Re: *PJM Interconnection, L.L.C.*, Docket No. ER18-\_\_\_\_\_  
Third Revised ISA, SA No. 2962; Queue No. Z2-083

**I. Description of Third Revised Service Agreement No. 2962**

## **II. Changes from Second Revised Service Agreement No. 2962**

### SINGLE-LINE DIAGRAM

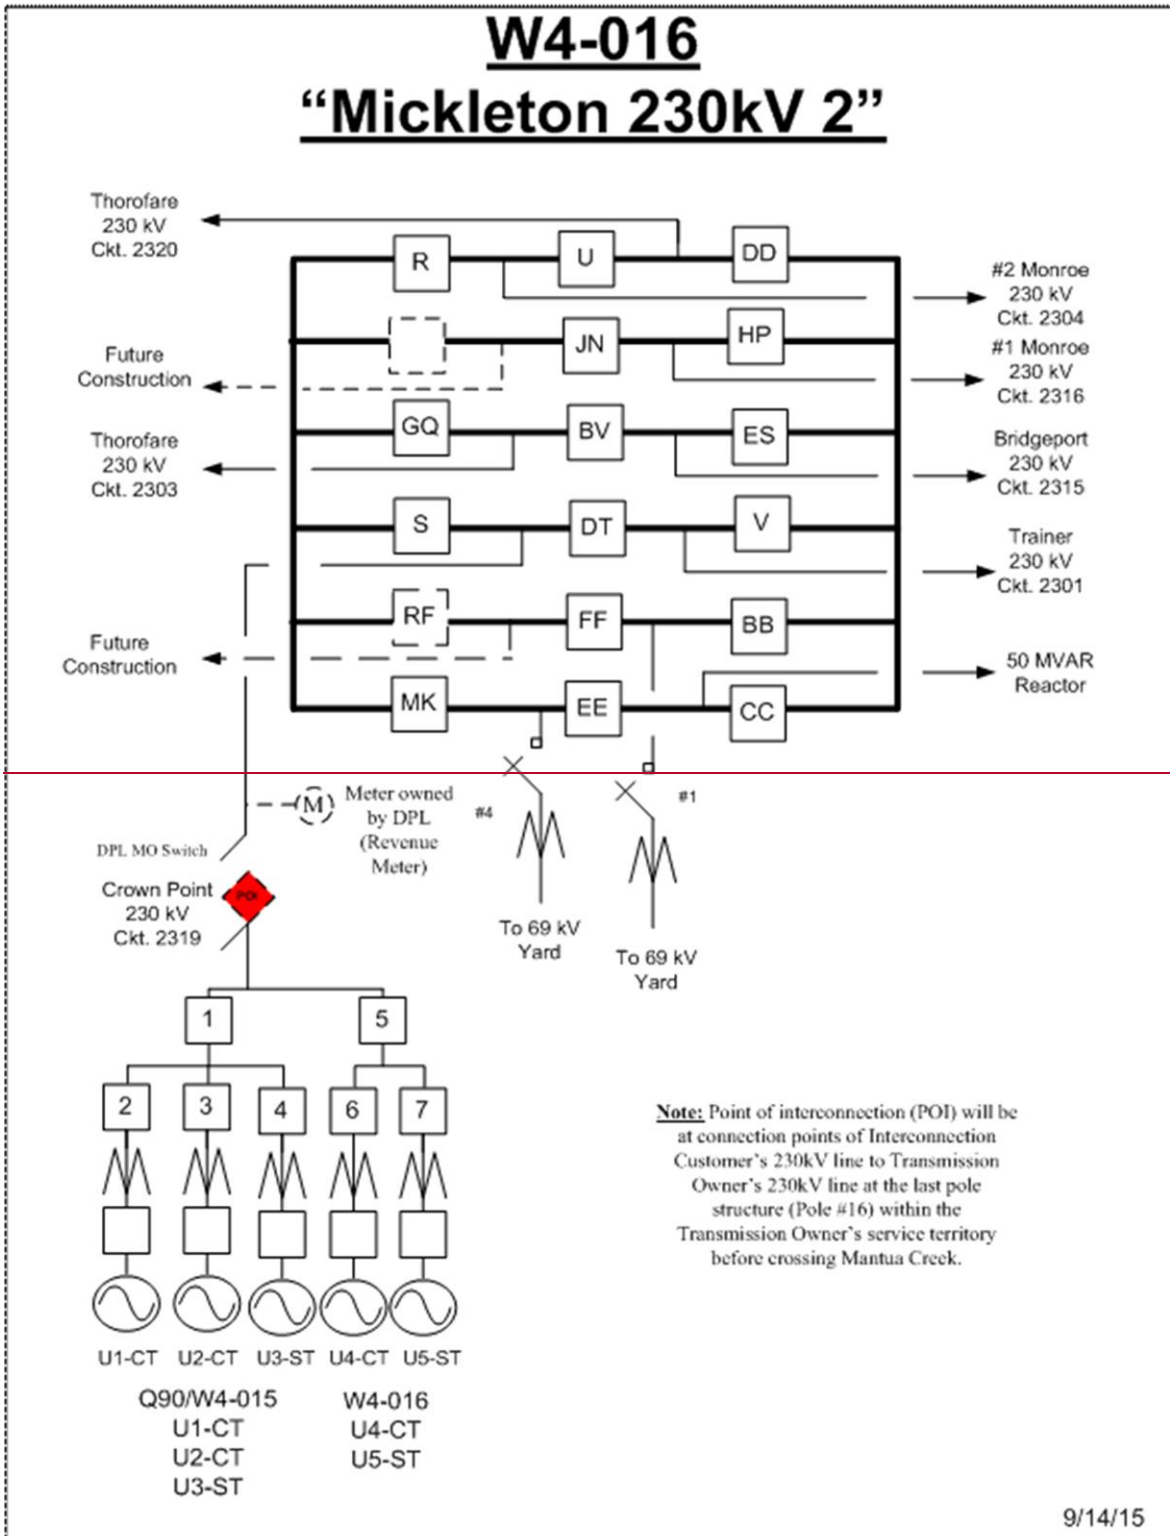
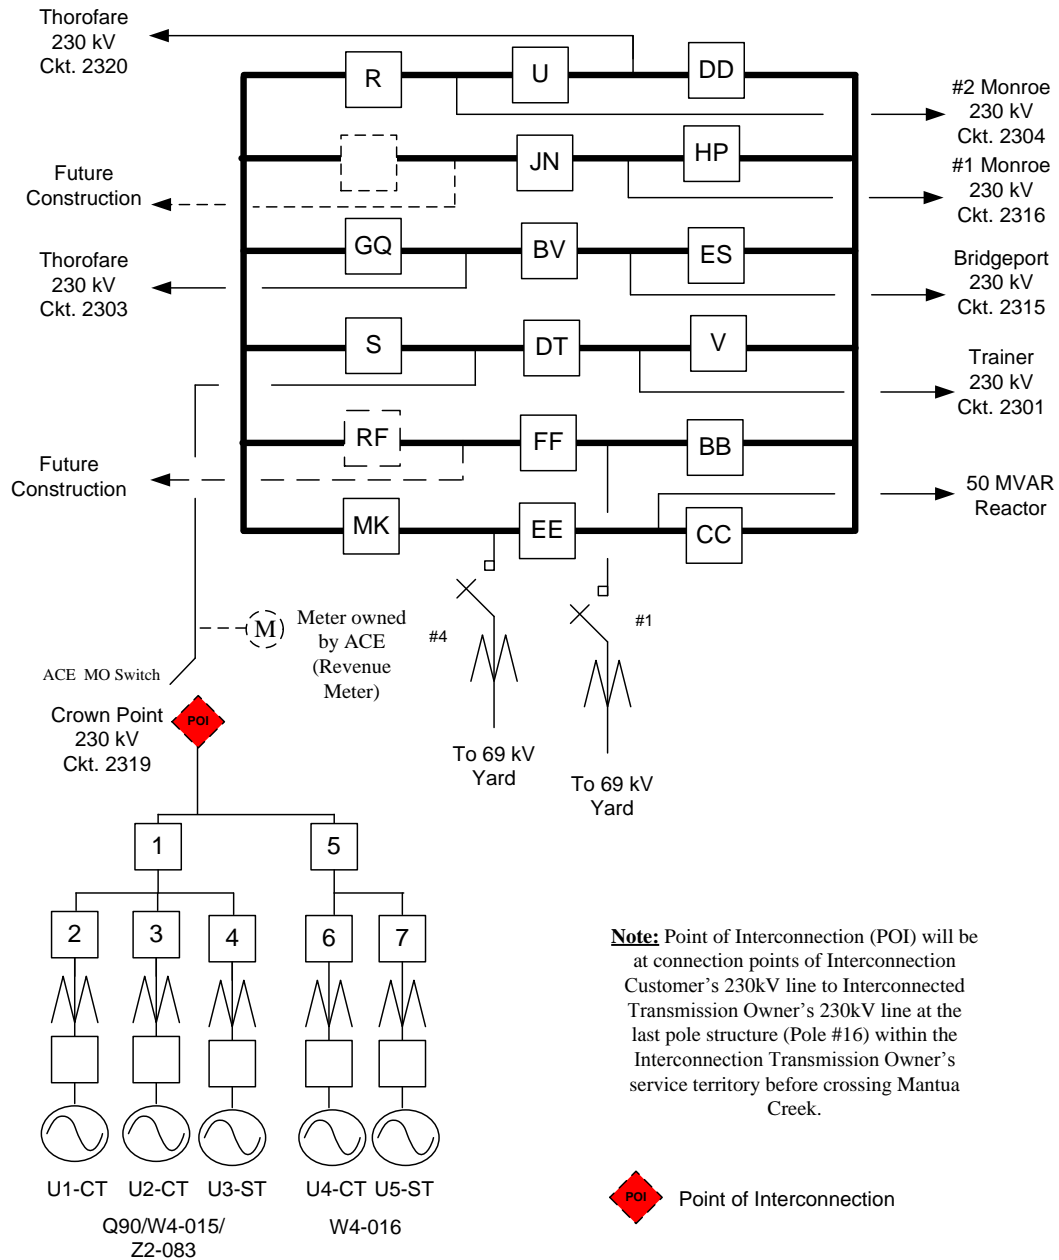
The single-line diagram set forth in Schedule B has been revised to reflect the facilities associated with Queue #Z2-083. The list of metering equipment contained in Schedule C has been revised for clarity and to reflect the current requirements. Similarly, the applicable technical requirements and standards set forth in Schedule D have been revised to reference the current standards.
